PROJECT Hillsborough County Sheriff's Office
Firing Range and Workout Gym
Pinebrooke Business Park

PROJECT NUMBER 1626/ 05-07

ADDENUM NO. One (01)
ADDENUM DATE 02/15/17

FLOOR PLAN
FIRING RANGE

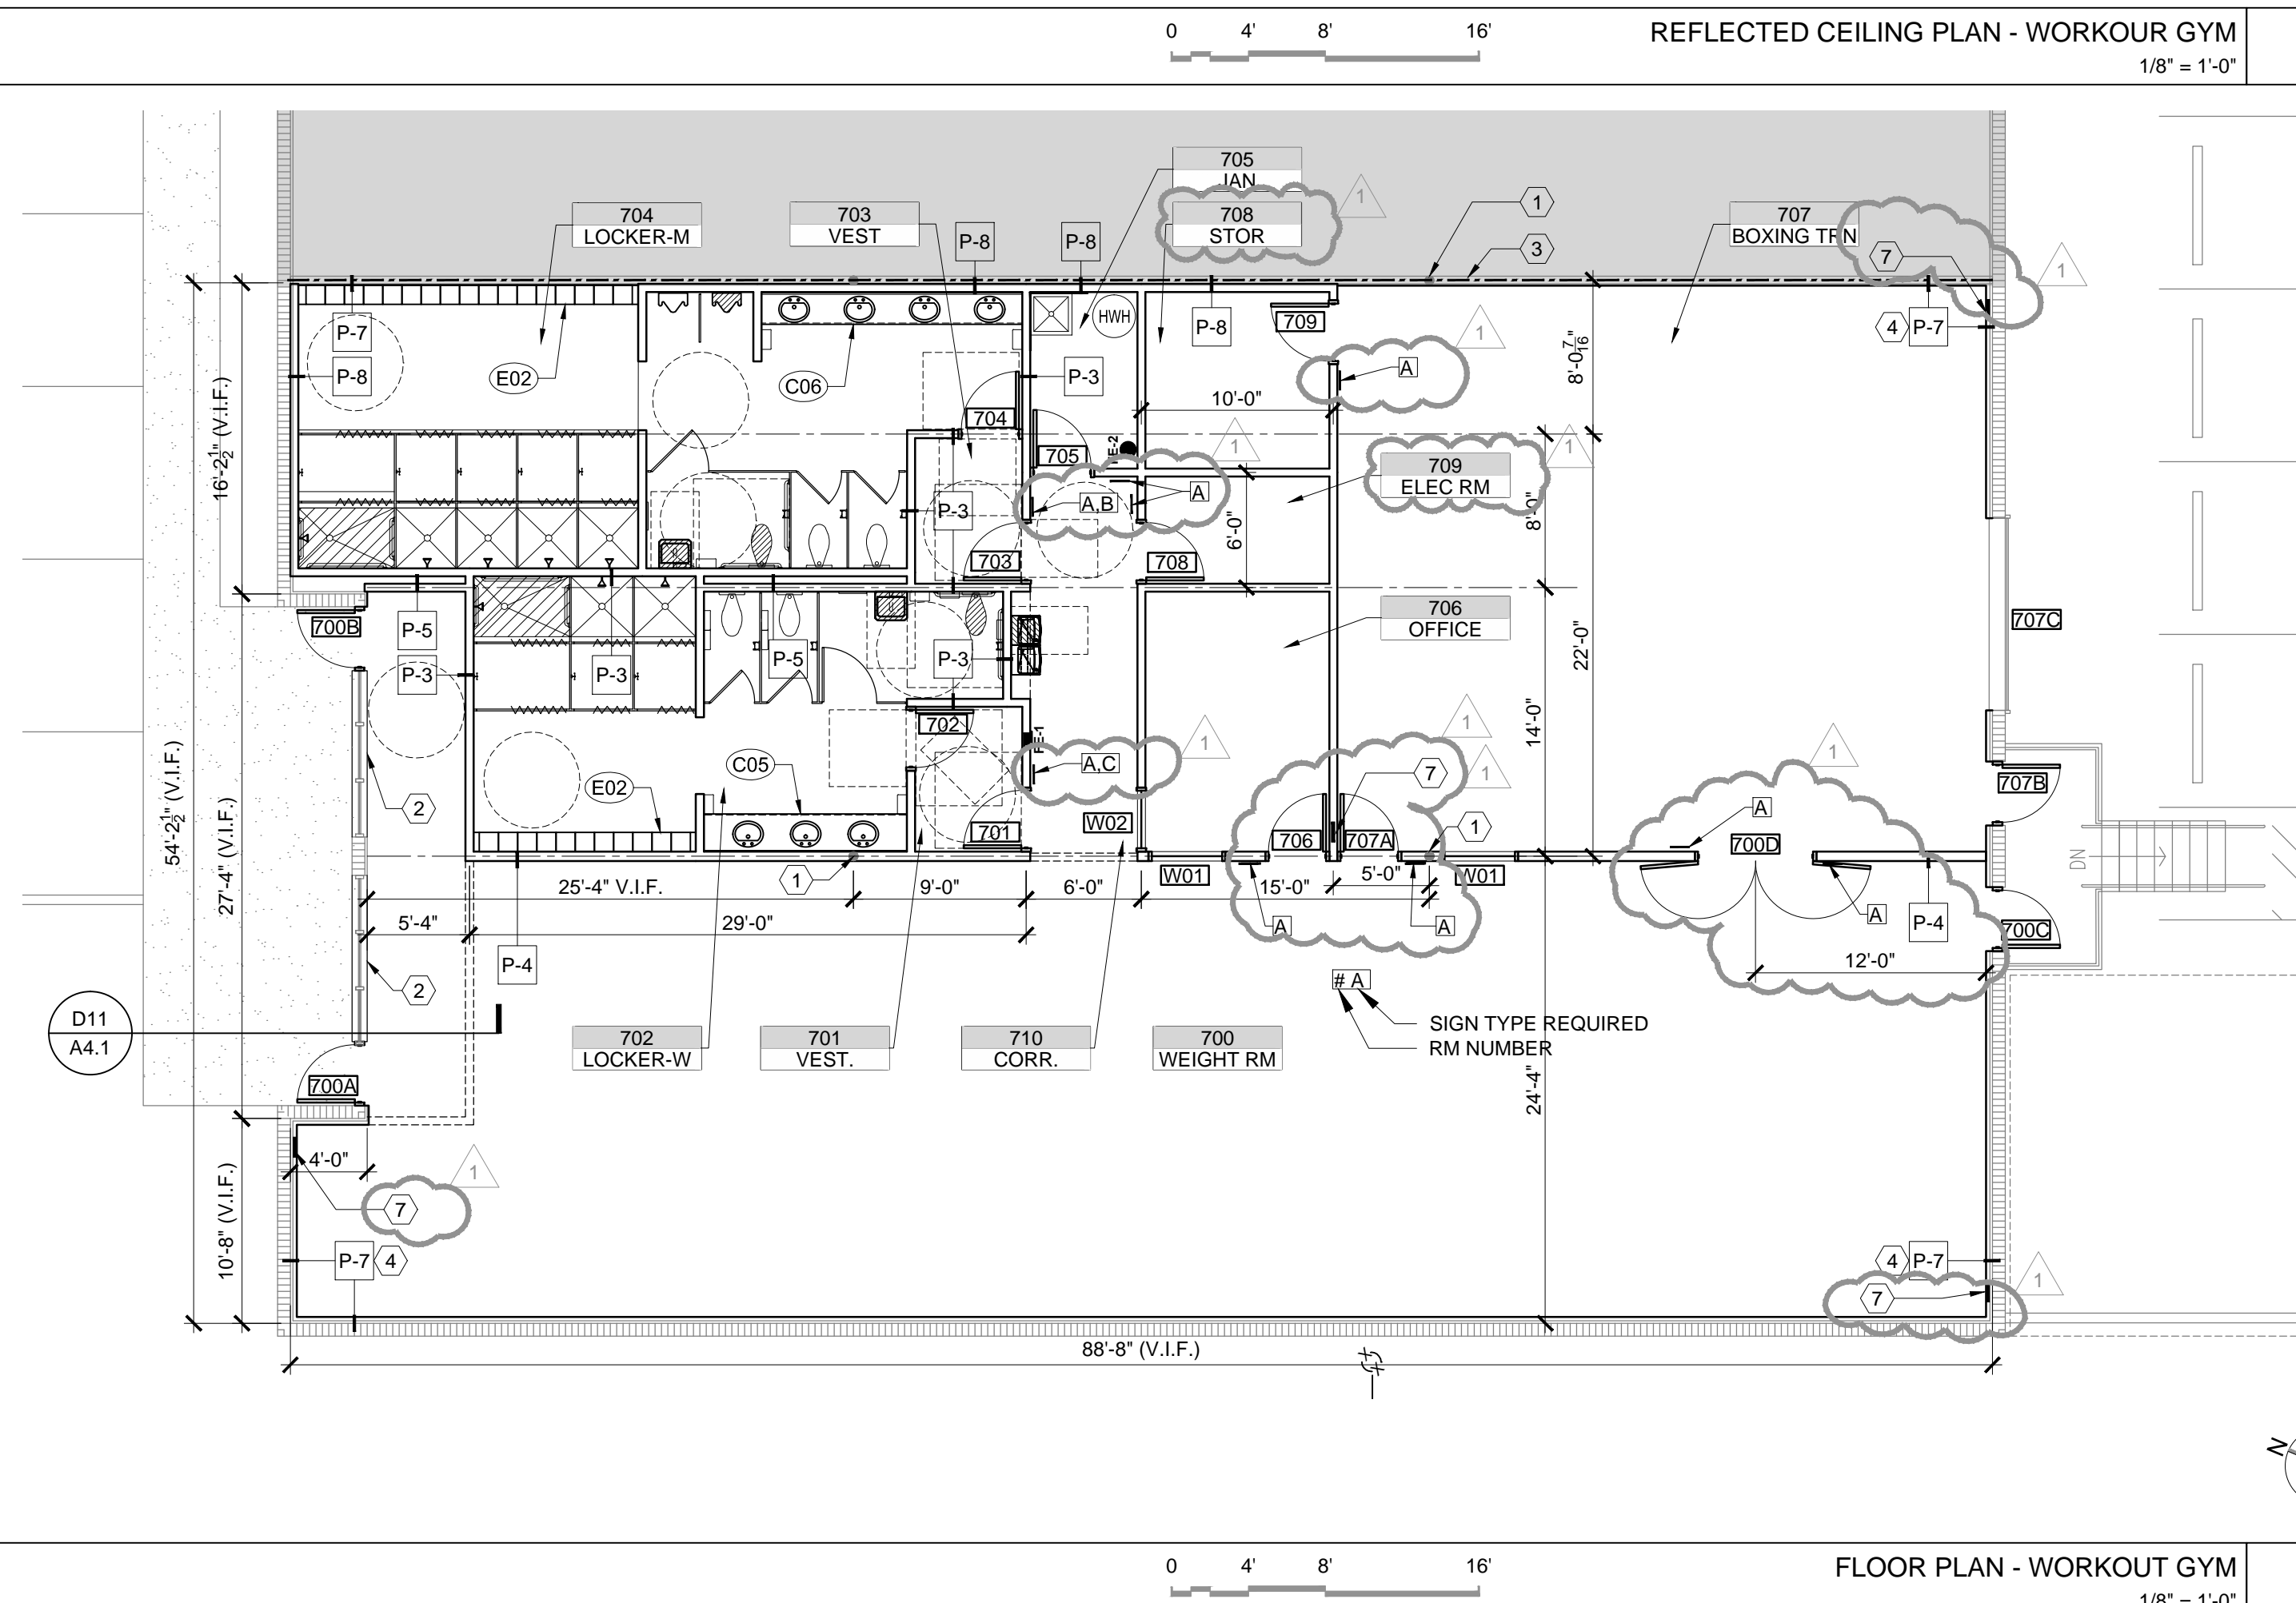
4. Sheet No. A1.2 – FLOOR PLAN FIRING RANGE
 - A. Revise location of mop sink and water heater in Janitor's Closet #610.
 - B. Revise the Mechanical Yard dimensions and construction.
 - C. Revise Plan to locate the air compressor.
 - D. Partition Type P-14 added to Plan.
 - E. Provide pocket in Training Room APC for overhead door clearance.
 - F. Revise Plan to indicate signage locations.
5. Sheet No. A1.3 – FLOOR PLAN FIRING RANGE
 - A. Storage Room 708 and Electrical Room 709 locations have been revised.
 - B. Revise Specific Notes to include the following " 7. PROVIDE WOOD BLOCKING @ 9'-0" AFF FOR OWNER PROVIDED AND INSTALLED FAN."
 - C. Revise Plan to include locations for fan blocking.
 - D. Provide pocket in Boxing Training Room APC for overhead door clearance.
 - E. Provide double door between Weight Room and Boxing Training Room.
 - F. Revise Plan to indicate signage locations.

ENLARGED TOILET
ROOM PLANS
AND ELEVATIONS
A2.1

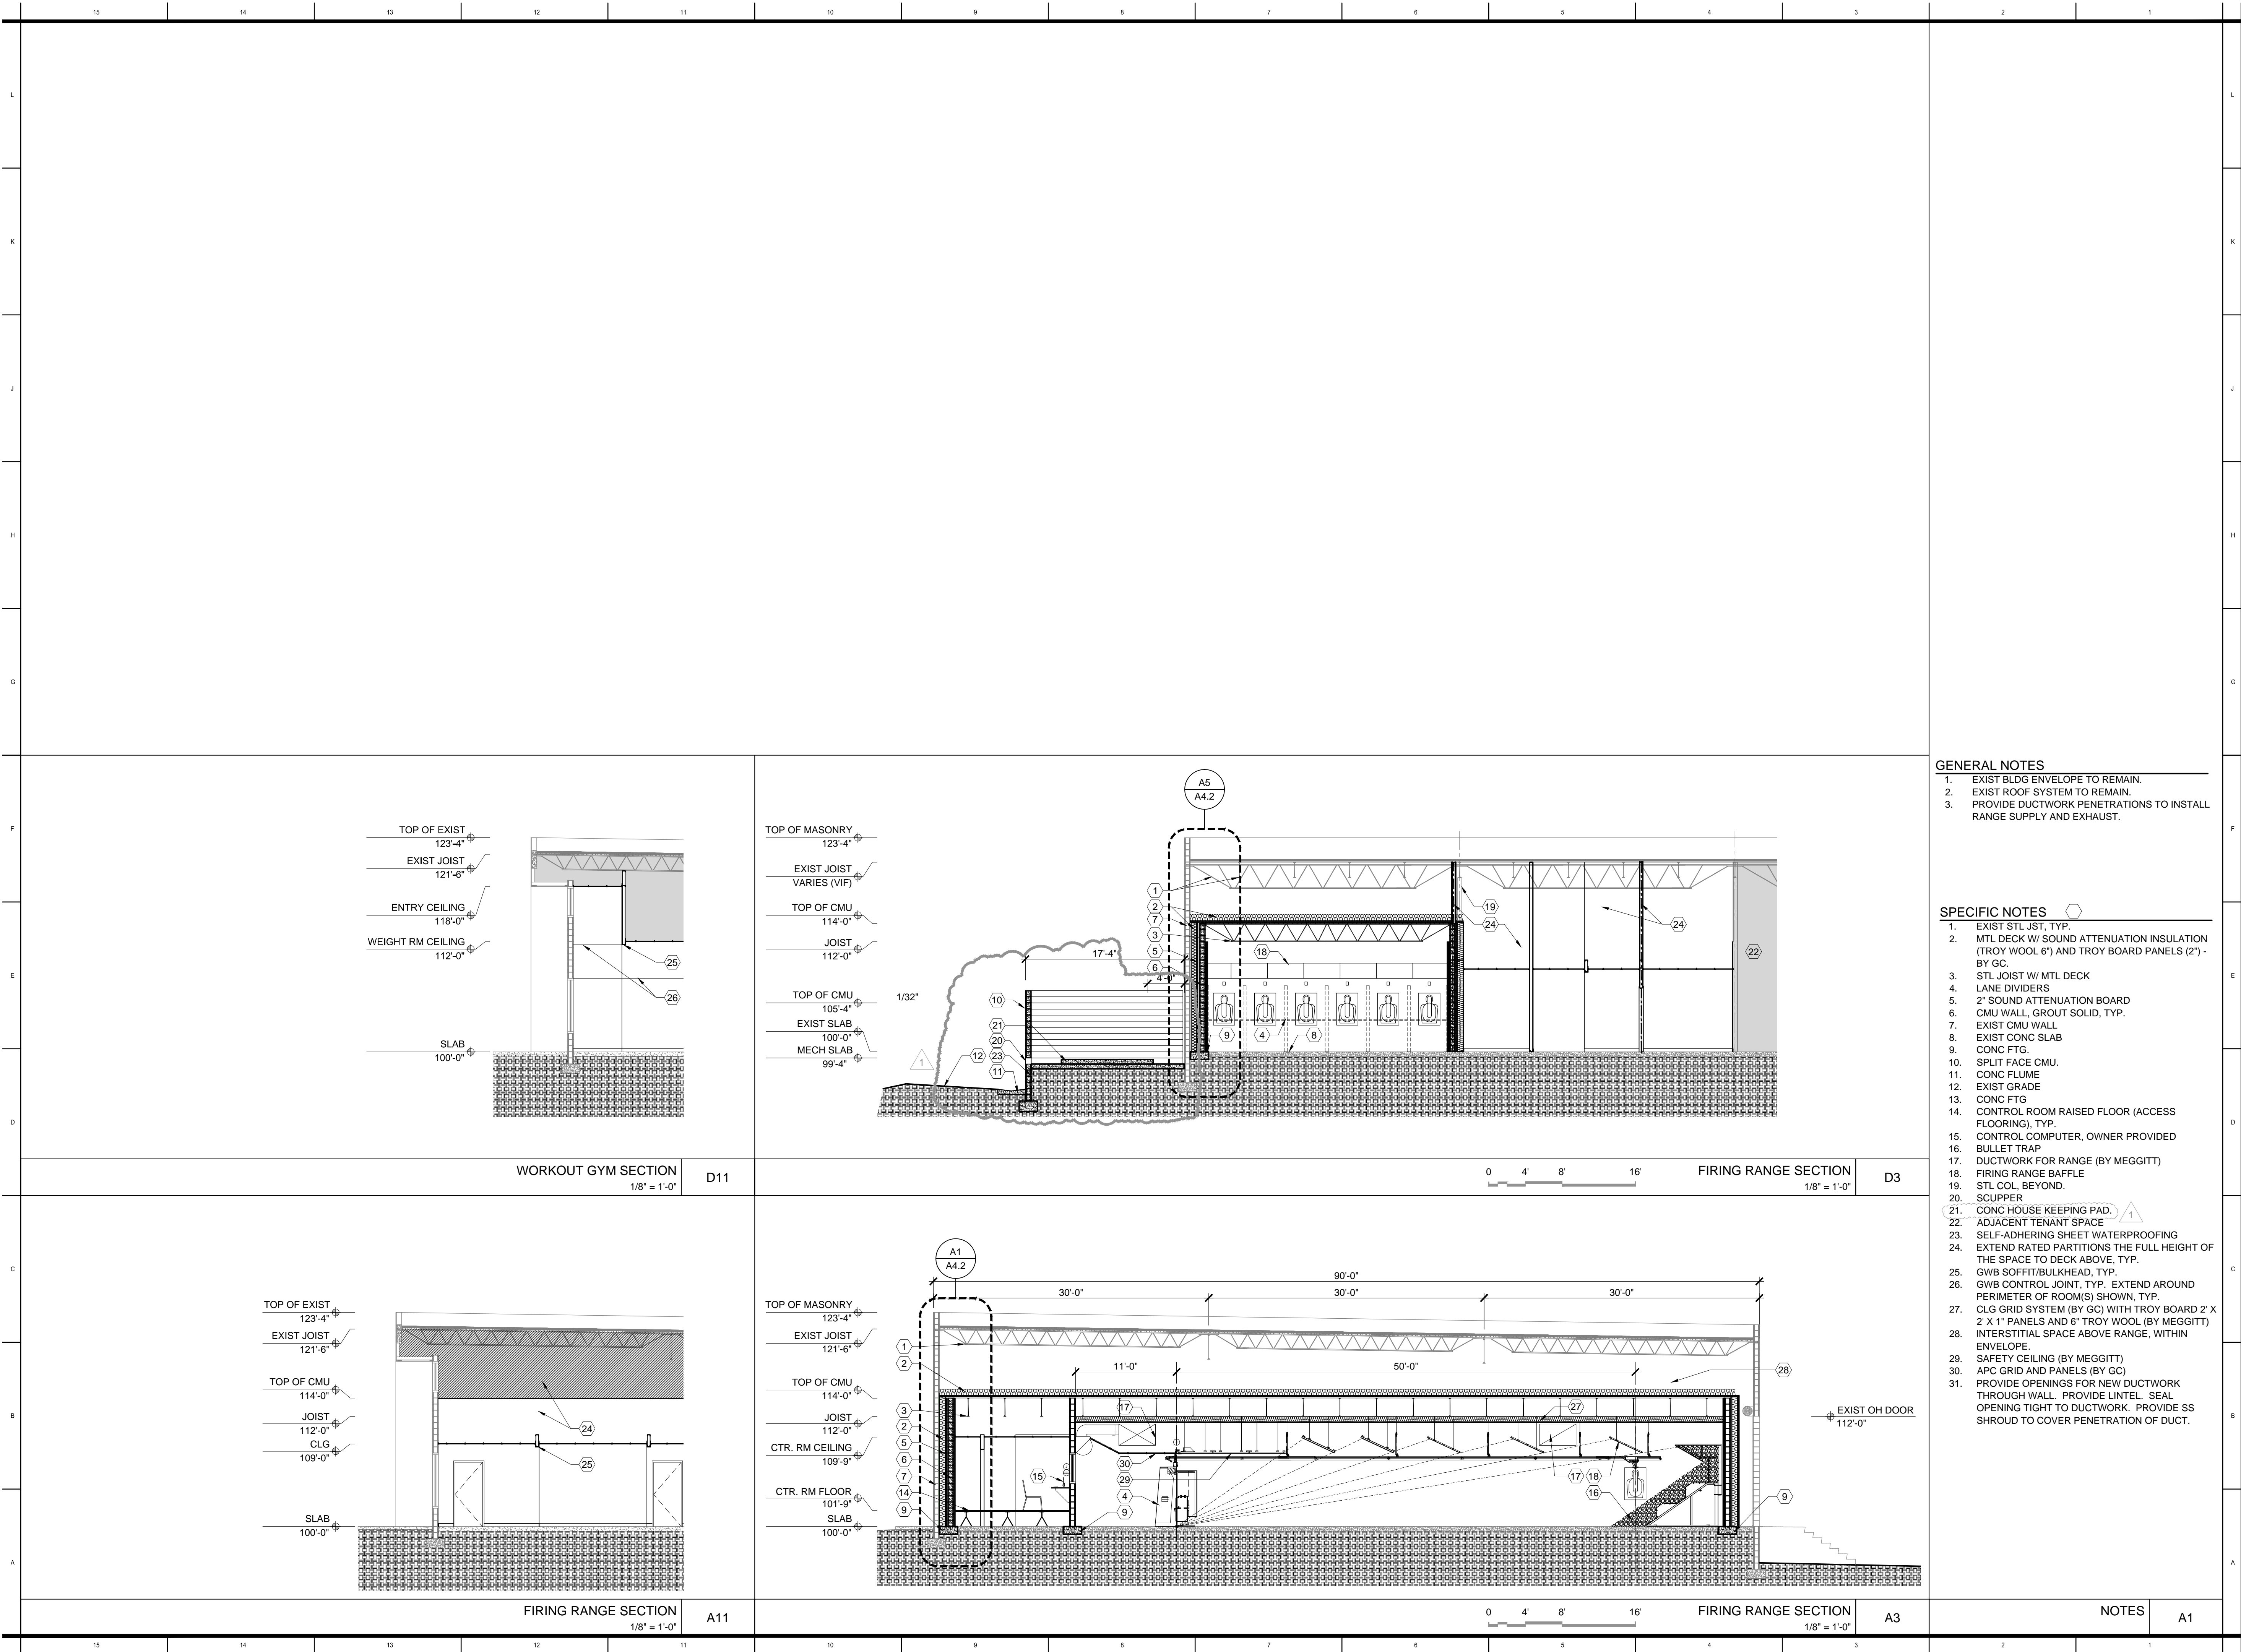
6. Sheet No. A1.4 – DEMOLITION PLAN
 - A. Add Sheet A1.4, dated 2/15/17 to the Drawings.
7. Sheet No. A2.1 – ENLARGED TOILET ROOM PLANS AND ELEVATIONS
 - A. Detail F1 – Clarify Note #7.

- B. Detail H1 – Clarify Note #7.
 - C. Relocate Mop Sink and mop holder.
8. Sheet No. A4.1 – BUILDING SECTION
 - A. Modify mechanical Yard Enclosure.
9. Sheet No. A4.3 – PARTITION TYPES
